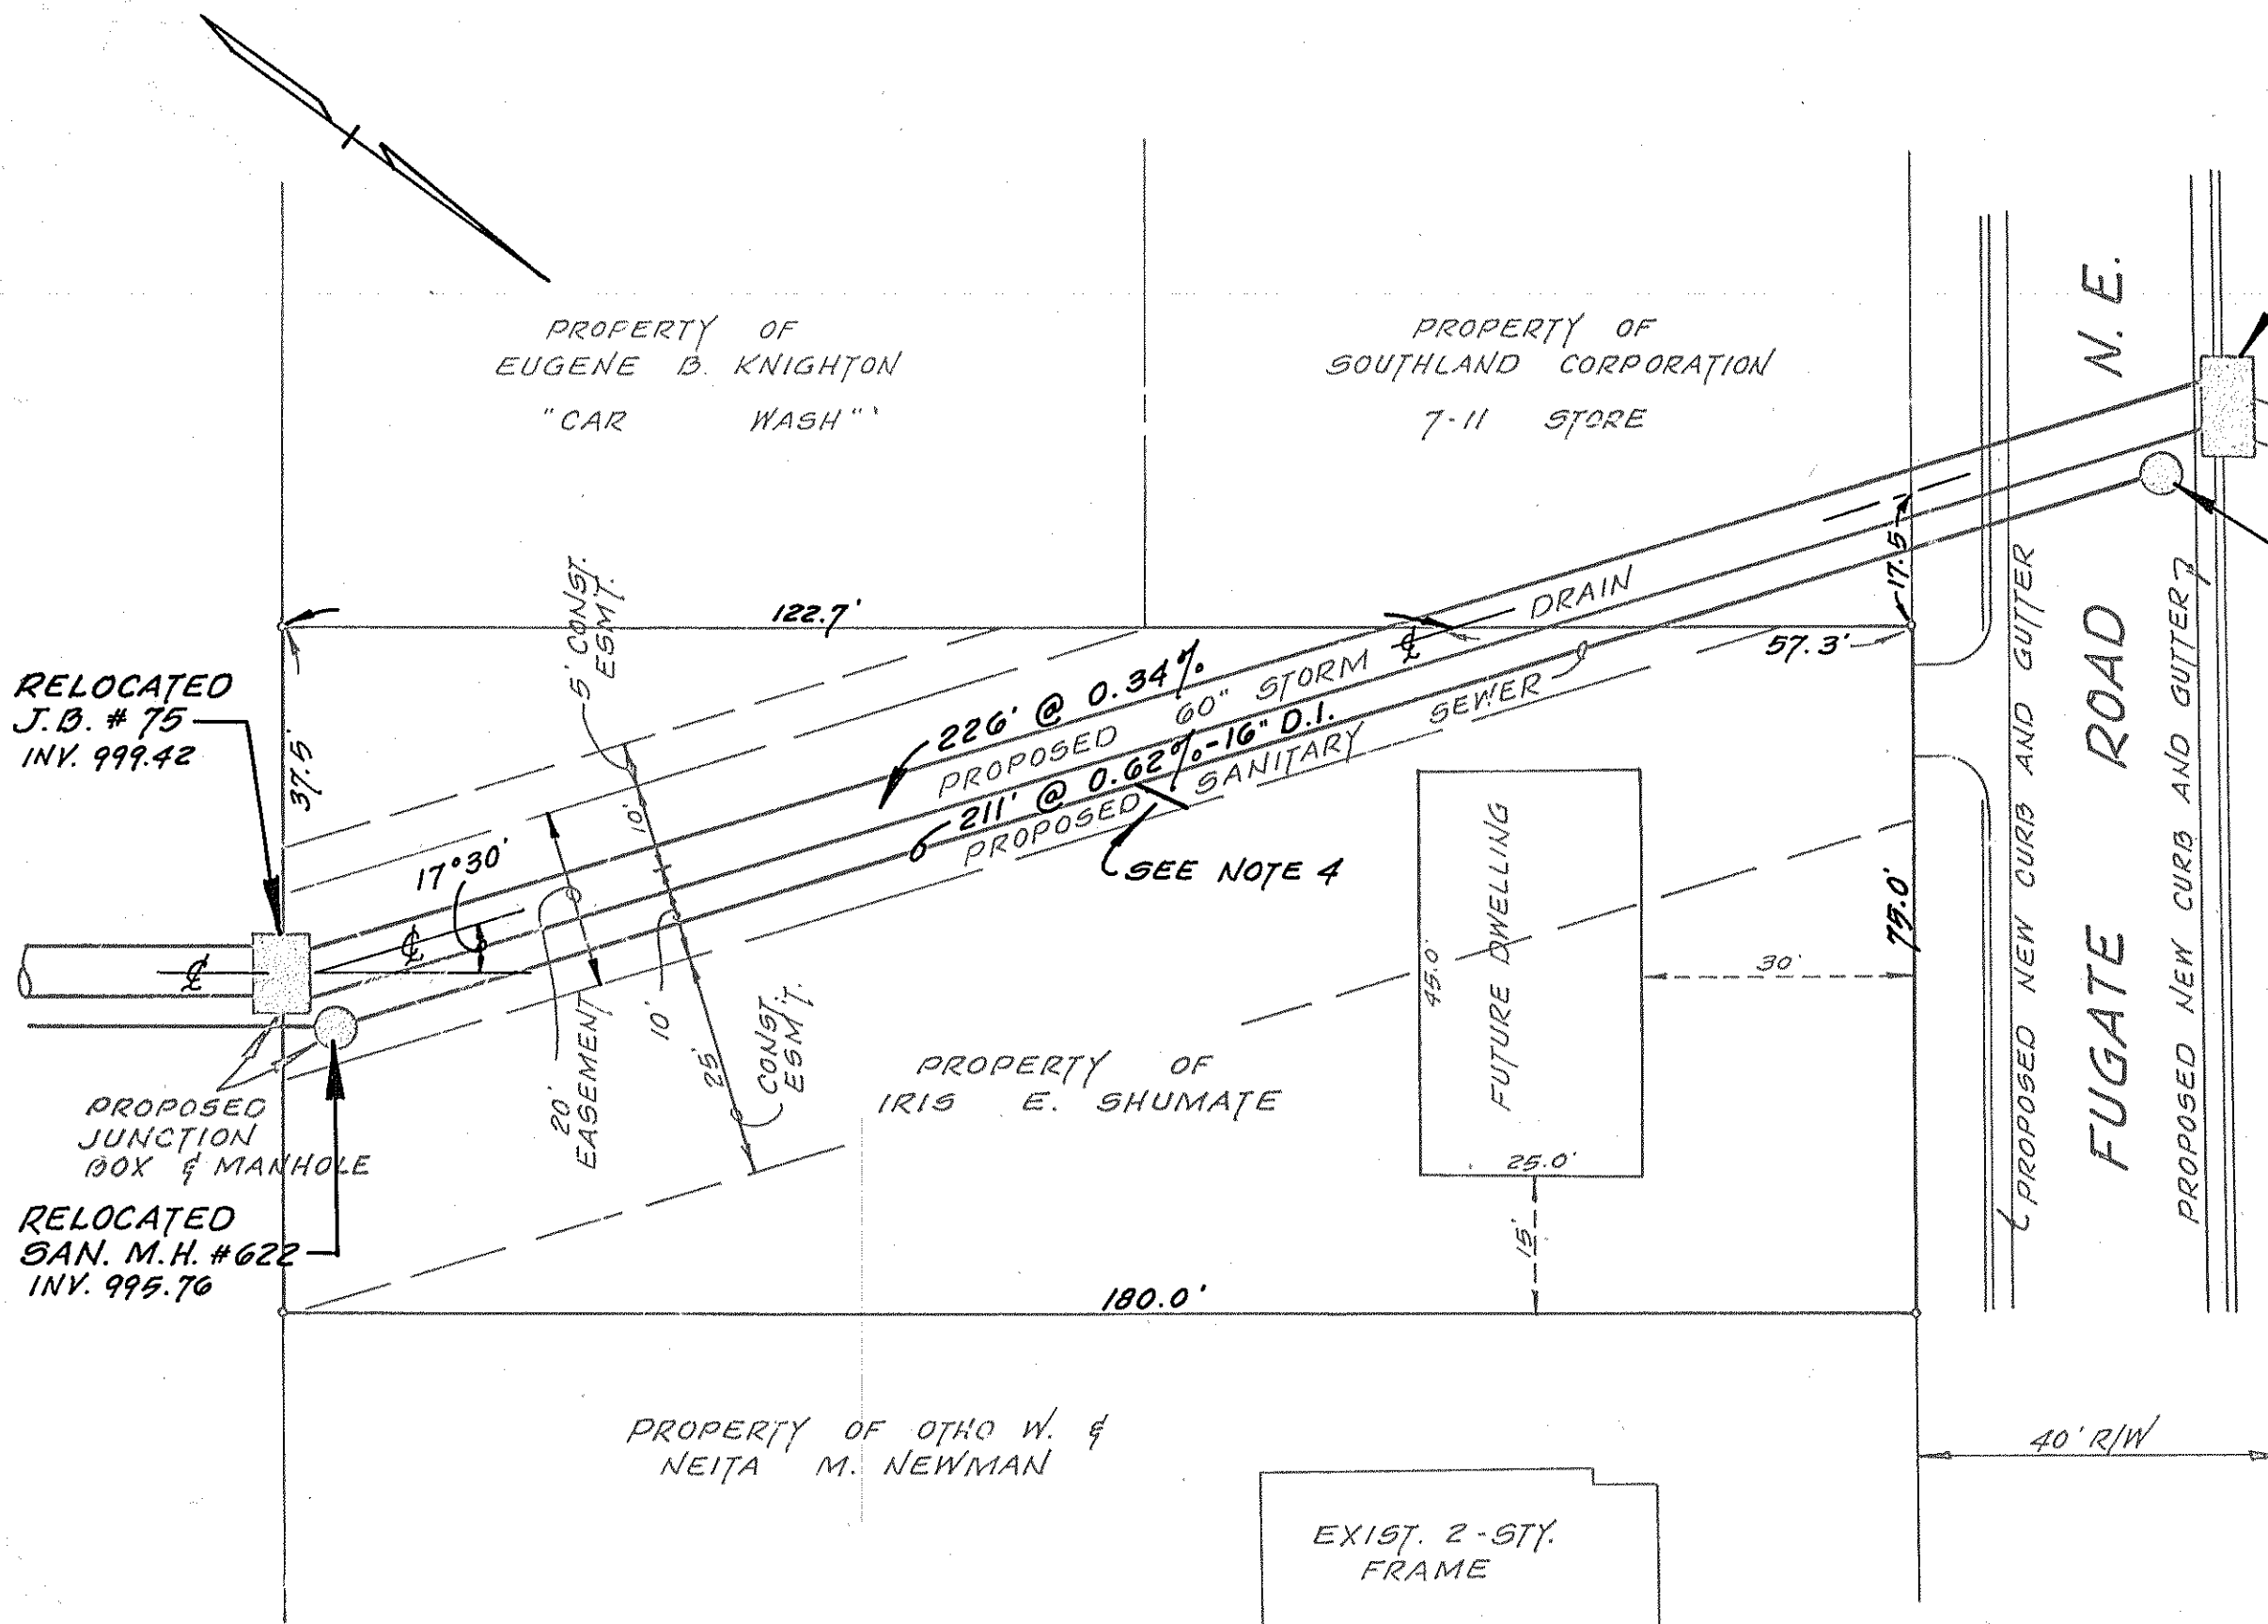
JB #78
INV. OUT 1000.19
INV. IN 1000.69 - SEE
NOTE ON SH. 28

SAN. M.H. #624
INV. OUT 997.06

RELOCATED
J.B. #75
INV. 999.42

RELOCATED
SAN. M.H. #622
INV. 995.76

- NOTES:
1. LOCATION OF JB #78 IS UNCHANGED.
 2. INVERTS OF RELOCATED JB #75 AND RELOCATED SAN. M.H. #622 ARE SAME AS PIPES AT THESE LOCATIONS PRIOR TO THE RELOCATIONS.
 3. EASEMENT ON SOUTHLAND CORP. (7-11) PROPERTY HAS NOT CHANGED.
 4. INSTALL A SAN. SEWER LATERAL AT THIS APPROX. LOCATION, EXTEND TO ESM'T. LINE AND CAP (WATERTIGHT) FOR FUTURE CONNECTION. OBTAIN AN ACCURATE DESCRIPTION OF THE LOCATION AND MARK ON RECORD PLAN SET.
 5. LOCATION OF SAN. M.H. #624 IS UNCHANGED. INVERT SHALL REMAIN AS SHOWN. ANY ADJUSTMENT SHALL OCCUR IN THE SLOPE.
